# Fuel Cell System Cost for Transportation—2008 Cost Estimate

## Independent Review

# Independent Review Panel Summary Report

From: Independent Review Panel, Fuel Cell System Cost for Transportation – 2008 Cost Estimate  
To: Dr. Michael A. Duffy, NREL, DOE Hydrogen Systems Integrator  
Subject: Independent Review Panel Report

**Figure 1. Argonne National Laboratory PEM system model used by TIAX for the cost analysis**

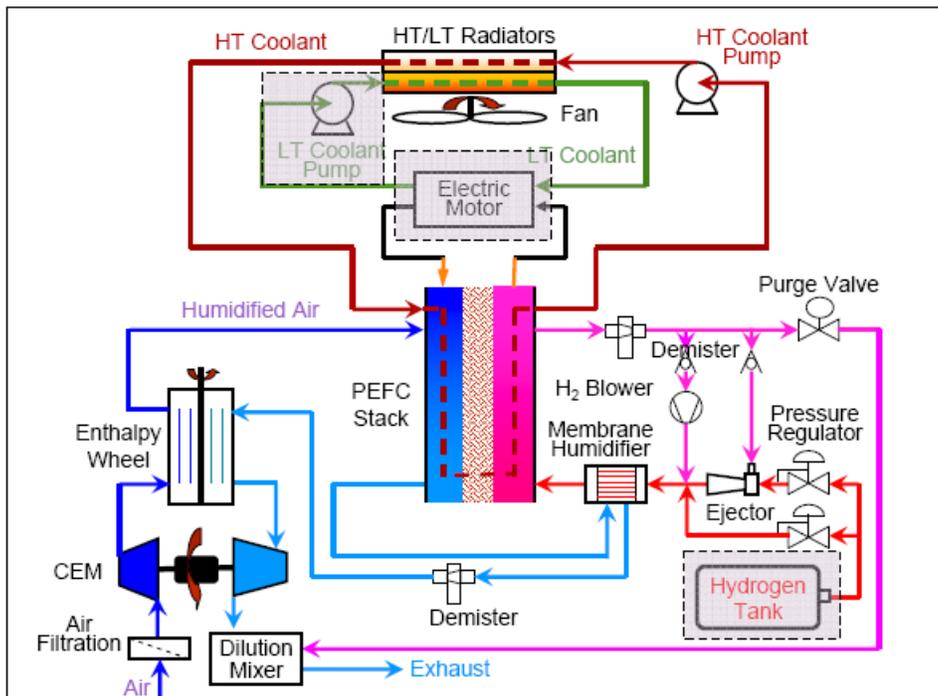
Very important to the TIAX analysis is the assumption of an EWH and the Honeywell CEM. The two components will influence the parasitic power and gross PEM system power requirements.

The water management subsystem identified by TIAX is not considered representative of today's technology or future PEM technology by the industry experts and the Panel. The major components of the water management subsystem are the EWH and the membrane hydrogen humidifier (MH). The major technical issue is with the EWH; based on industry interviews and FCTT, no fuel cell OEM uses the EWH to humidify the air. The EWH is introduced to the system via the ANL model and has the advantage that the air exiting the CEM (see Figure 1) does not need to be cooled before it enters the EWH.

Figure 2. Flow schematic of the 80-kW<sub>net</sub> direct hydrogen PEM system model used by DTI for the cost analysis

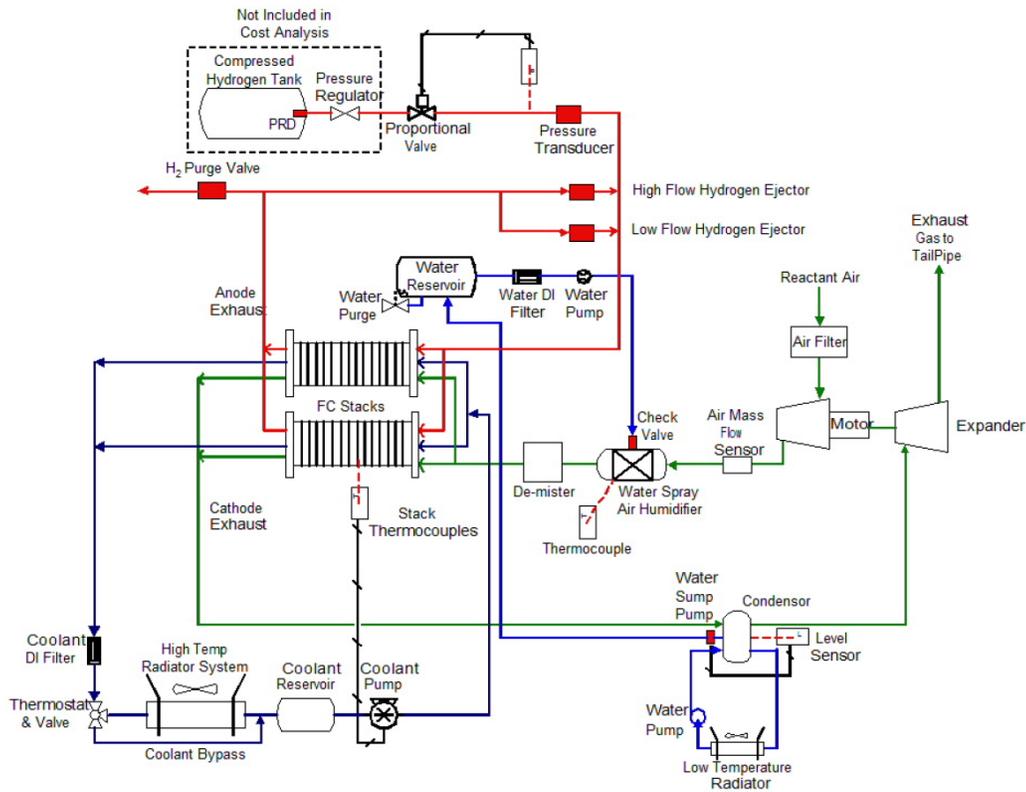
- A thermodynamically correct system configuration by DTI would improve its ability to select and size components, which would influence the overall cost analysis.

- DTI's use of a thermodynamically correct model for the system would enhance confidence in its analyses.
- The contractors should adopt a common, industry-accepted methodology for component cost analysis such as DMFA for more consistent future comparisons.

Figure 4. Ionomer cost projection

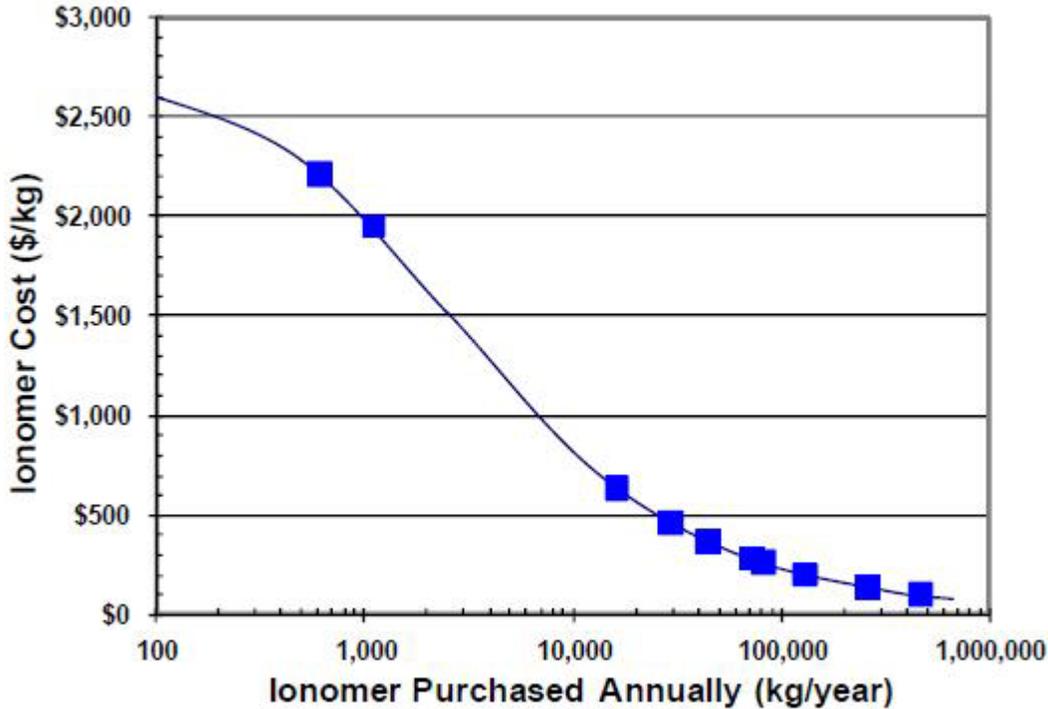
The cost assumed by DTI for Nafion in high volume (\$92/kg) is aggressive and perhaps fails to take certain key business factors into consideration. Even at high volume, the total production quantity for perfluorosulfonic acids (PFSA), including Nafion, will likely be less than 300 tonnes per year. Also, the tonnage for DuPont will be much less, as the overall market will be split between four or five companies.

If DTI's curve of ionomer cost reduction as a function of volume is correct (see Figure 4)<sup>14</sup> and if each supplier has about 50 tonnes/year of sales, the ionomer cost will be about \$400/kg. If the cost of manufacturing the membrane does not change, this analysis (if correct) would increase the membrane cost to approximately \$60/m<sup>2</sup> at 500,000 stacks/year. This is a significant difference from the \$16.62/m<sup>2</sup> estimated by DTI, which assumes that all membrane is produced by a single supplier.

**Figure 5. Roll processing process for depositing catalyst layers formed with edge seals using the decal transfer method; from 3M patent U.S. 7,195,690**

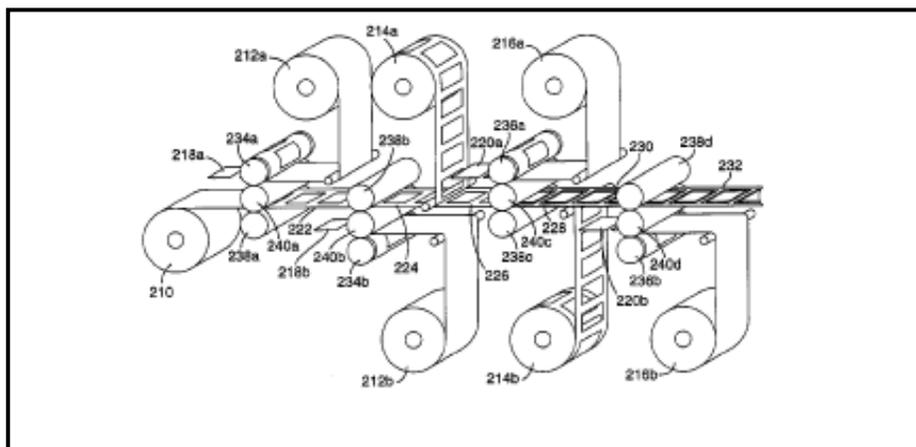
The continuous roll application of the catalyst layers will require a finite bonding period to hot bond the catalyst layer to the membrane that defines the production rate for the MEAs. TIAX did not identify the bonding period. Assuming 60 seconds as the rate controlling stage (two thirds of the hot pressing period<sup>20</sup>) for the hot bonding process and using the manufacturing criteria from the TIAX report,<sup>21</sup> 400 roll processing systems would be needed to meet the 500,000 systems per year production automotive requirements. Industry interviews identified that several production lines will be needed to reach constant state of manufacturing. The reproducibility of the 400 MEA manufacturing systems would need to be very high to meet the TIAX assumption of 100% yield.

TIAX did not discuss fabricating multiple MEAs with a wide membrane, forming a continuous, edge-to-edge coating of catalyst, and subsequently applying wide GDLs before slitting the wide MEA into rolls ready for die cutting. The concept of an edge-to-edge coated membrane may have technical difficulties with corrosion and shorting of the catalyst layers. Although the wide membrane with edge-to-edge catalyst coating may provide the highest production rate, the durability will need to be demonstrated.
